marantz® SERVICE BULLETIN		Date: 28-Dec-2004	Model: SR7400/SR7500/SR8500
		Page: 1 / 1	REF.NBR: MZ04-085
Level		Application:	
★ ★		See below	
		Subject: FL Display does not light up.	
		Int.ref:

SR7400

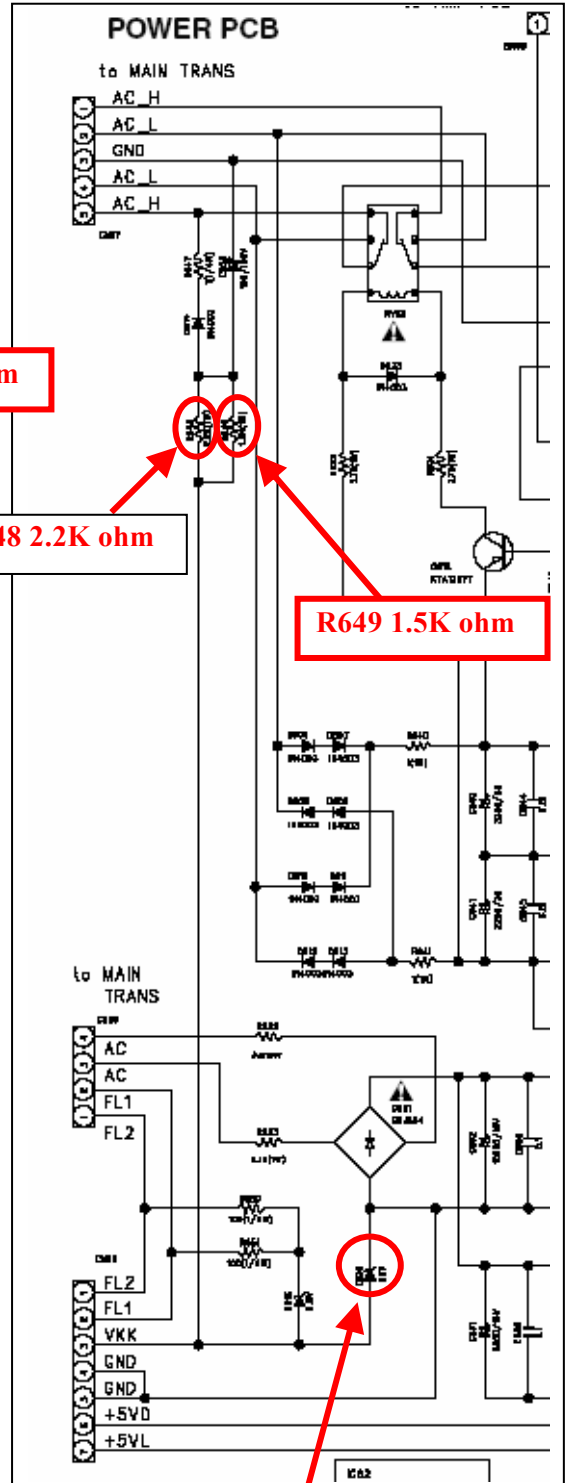
1. In condition, AC input is about 10% overvoltage than Rated voltage and the sound is not outputted for a long time.
2. The DIODE (POS NO.D616) may short-circuit. R648 and R649 are broken by this short-circuit.

D616 Zener Diode part no. 90M-HD302190R

1. POS.NO **R649** RESISTOR (**1.5K OHM**) is changed to RESISTOR(**2.2K OHM**) on the POWER PCB

SR7500 / SR8500

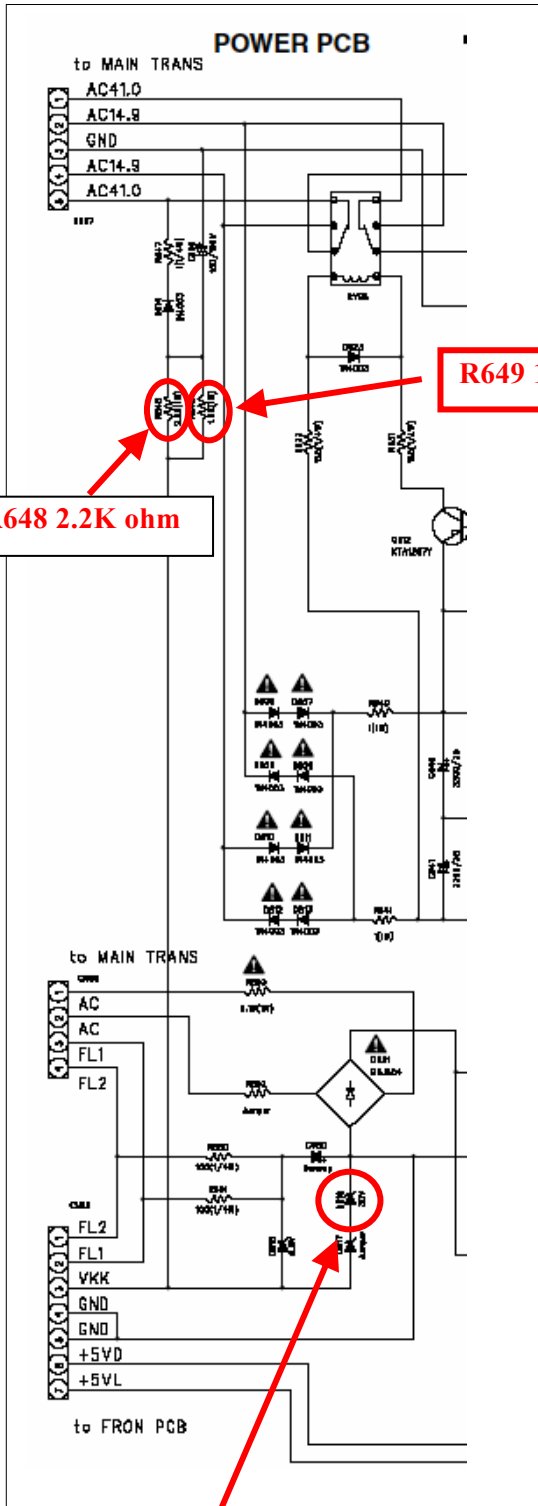
D616 Zener Diode part no. 90M-HD302190R
